# DR-35567

## Design review report

Aim of this document is to describe suggestions and corrections that Telit advises to improve Ovoo Electronics customer application that integrates a Telit-Cinterion LE910C1-EUX module.

Figure 1. Modem footprint recommended.

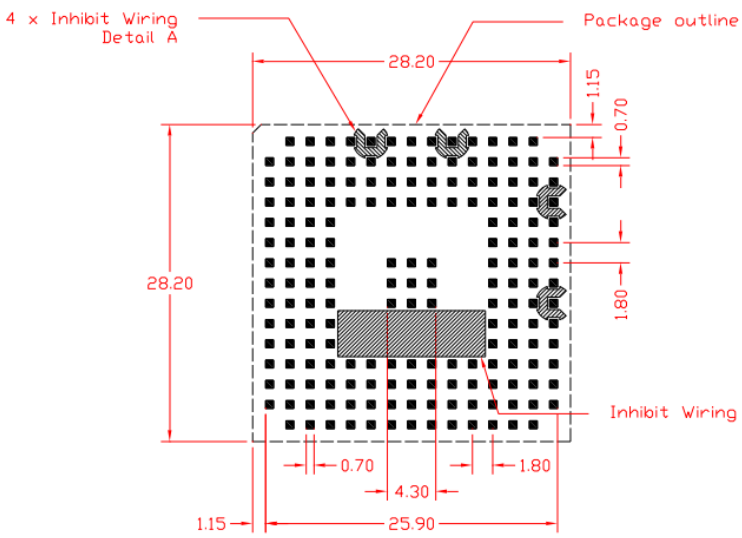
- ✖ The footprint of the modem is wrong: below is depicted the correct footprint.

Figure 2. RF waveguide parameters calculated.

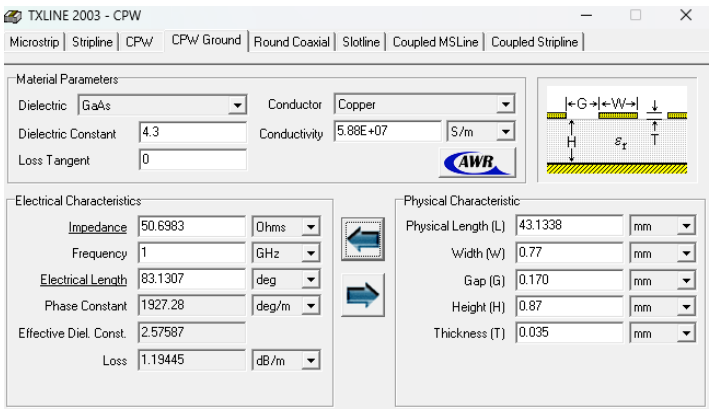
- ○ The RF waveguide has the 50 Ohm characteristic impedance required.
